Contract #: 04-0120F4Cty: SF/ALA Rte: 80 PM: 13.2/13.9File #: 69.25B**QUALITY ASSURANCE -- NON-CONFORMANCE REPORT****Location:** Changxing Island, Shanghai, P.R. China**Report No:** NCR-000648**Prime Contractor:** American Bridge/Fluor Enterprises, a JV**Date:** 23-Jan-2010**Submitting Contractor:** Zhenhua Port Machinery Company, Ltd (ZPMC), Changxing Island**NCR #:** ZPMC-0618**Type of problem:**

Reference Description: Counter Weights outside of the North end of Bay 17 are stored directly on the ground and MEP mounting brackets are bent

Job Name: SAS Superstructure

Subject: NCR No. ZPMC-0618

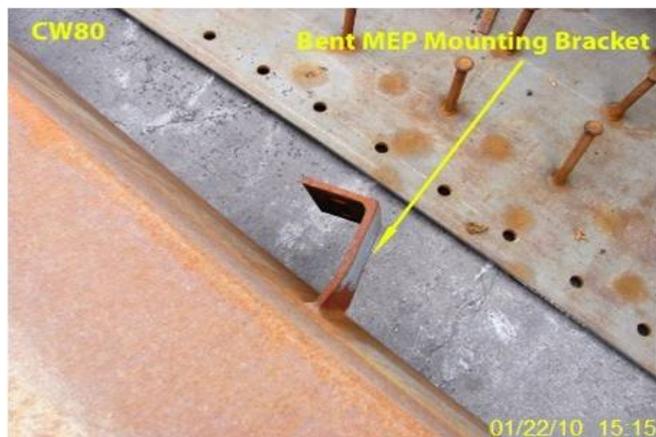
- OBG Counter Weight CW80 MEP mounting brackets (second and last) are bent.
- Nine (9) Counter Weights CW40, CW50, CW80, CW60, CW98, CW78, CW72, CW68 and CW104 were improperly stored. These Counter Weights are stored directly on the ground and are stacked unevenly on each other without the proper storage supports.
- These Counter Weights are located in the outside yard north of Bay 17.

CWs have been re-stored and are acceptable now

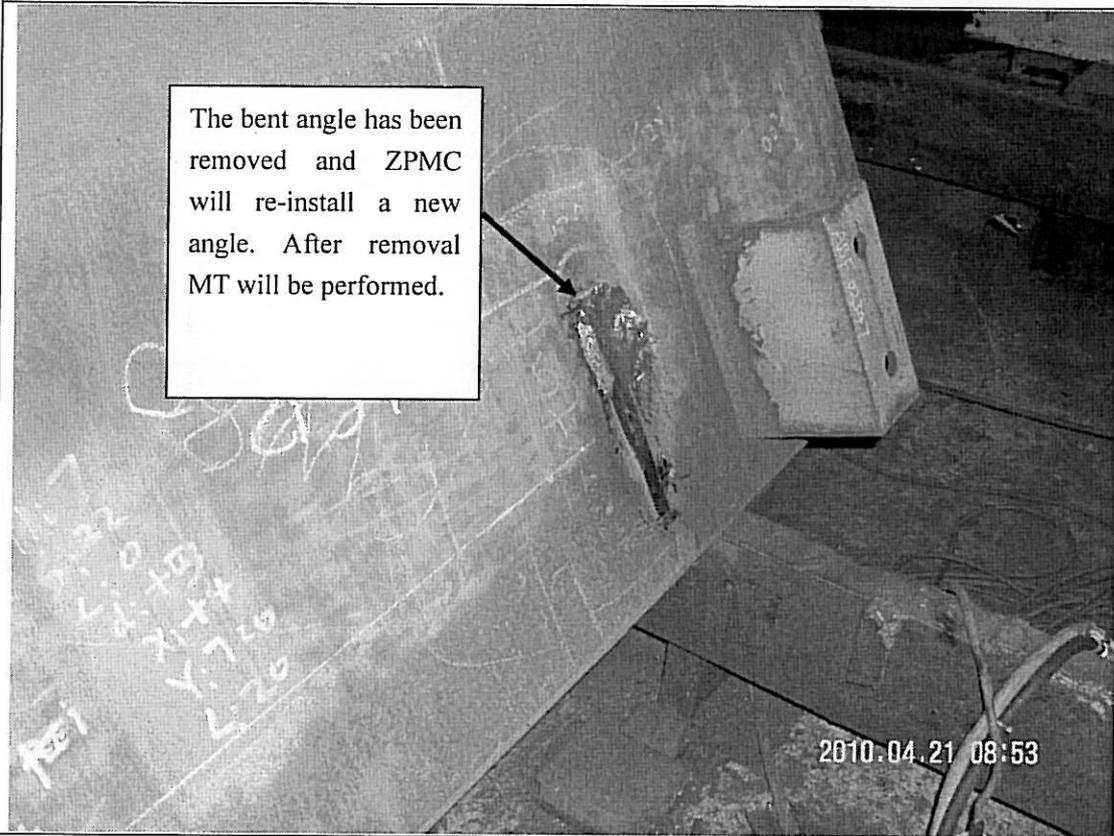
ZPMC acknowledges this problem and has written an internal NCR regarding this issue. These CWs has been re-stored with proper storage supports now. And ZPMC will replace the bent angle on CW80. Attached photos show the storage for CWs and the removal of the bent angle. ZPMC will perform MT before re-install the new angle at the grinding area on CW80 and after the angle is replaced, CT will be notified to perform NDT. Based on this, ZPMC is requesting closure of this NCR.
